IS-28B2/E0-25 MANDATORY SERVICE BULLETIN

PRODUCT : IS-28B2 GLIDER

SUBJECT : CHECK OF AIR BRAKE CONTROL HANDLES

COMPLIANCE: MODIFICATION RECORD CARD No. 28B2.07.1274

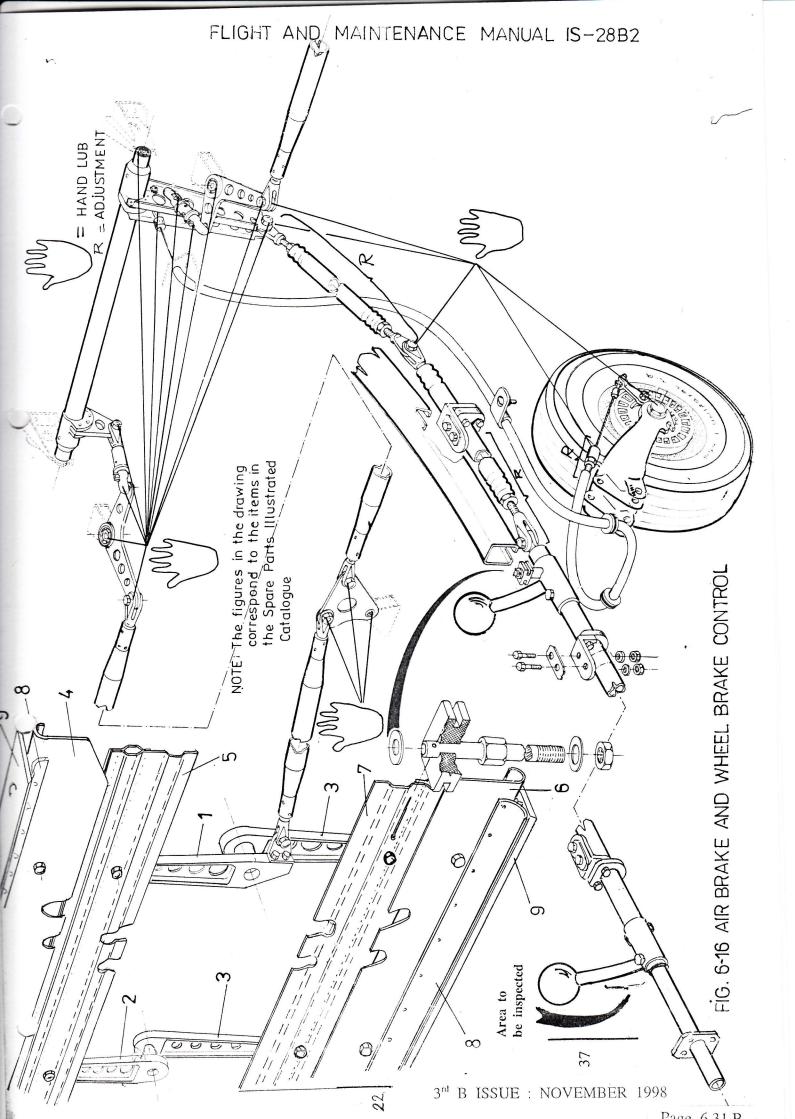
After every 100 flight hours, perform an inspection of the air brake control handles, welding and adjacent area (area shown in fig 6-16, page 6.31.B). Use a magnifier of minimum 1x10.

If any cracks are detected in the welding or adjacent area, stop the glider from flight and replace the two handles.

If any doubt exists, a penetrant dye may by used for crack detection.
